**ZONING AND PLATTING COMMISSION SITE PLAN
ENVIRONMENTAL VARIANCE REVIEW SHEET**

CASE NUMBER: SP-2012-0157D **ZAP COMMISSION DATE:** 8-7-2012

PROJECT NAME: Humboldt Residence

EV VARIANCES REQUESTED: LDC Sections 25-8-301 , To allow construction on slopes for driveway construction and LDC Section 25-8-342, To allow fill in up to a maximum of 14 feet for driveway construction

4 Humboldt - Year 1 Planting / Wall Finish

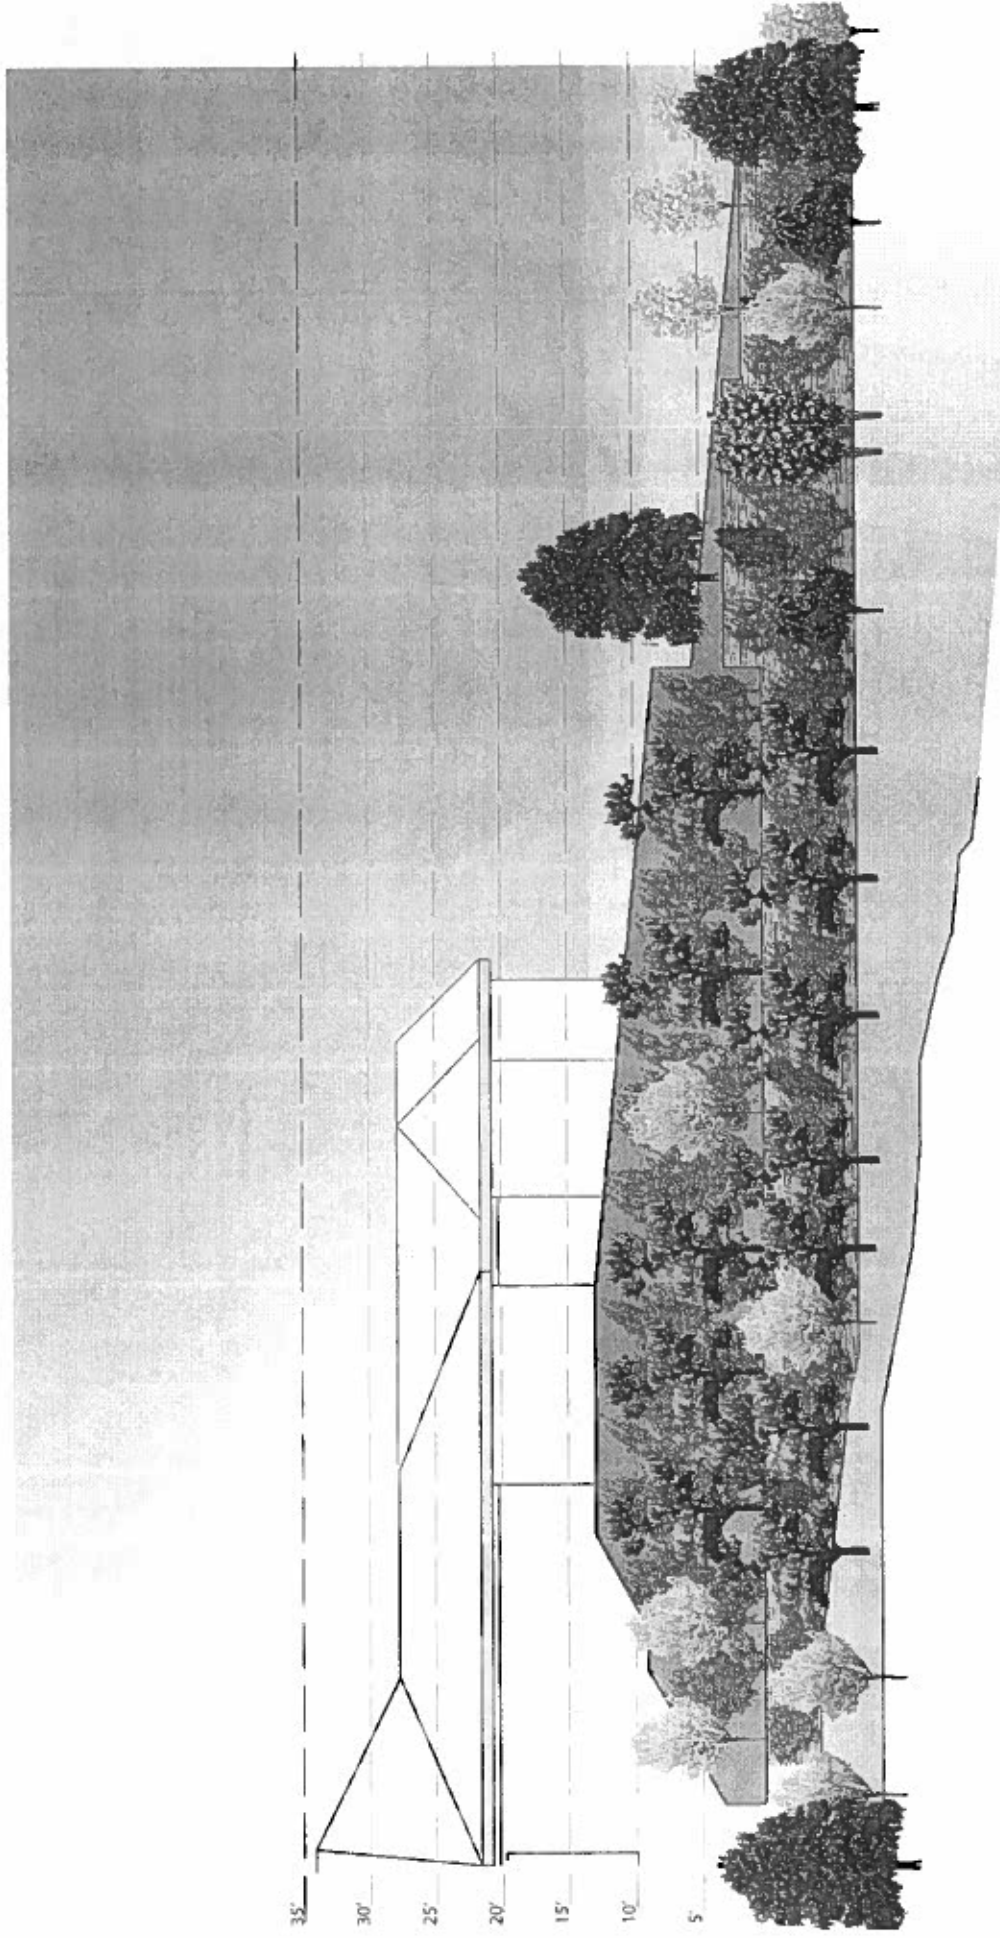
- a. That the upper wall shall be clad in stucco (to match the house) with STO mix #238, color to match Benjamin Moore Gray 2121-10;
- b. That the lower retaining wall shall be clad in 'Texas Mix' applied veneer stone;
- c. The planter wells comprising the lower wall will be planted in Japanese Black pine trees along with Hacienda Creeper and Evergreen Clematis vines. There are also 2 peach trees at the stairwell end of said planters.
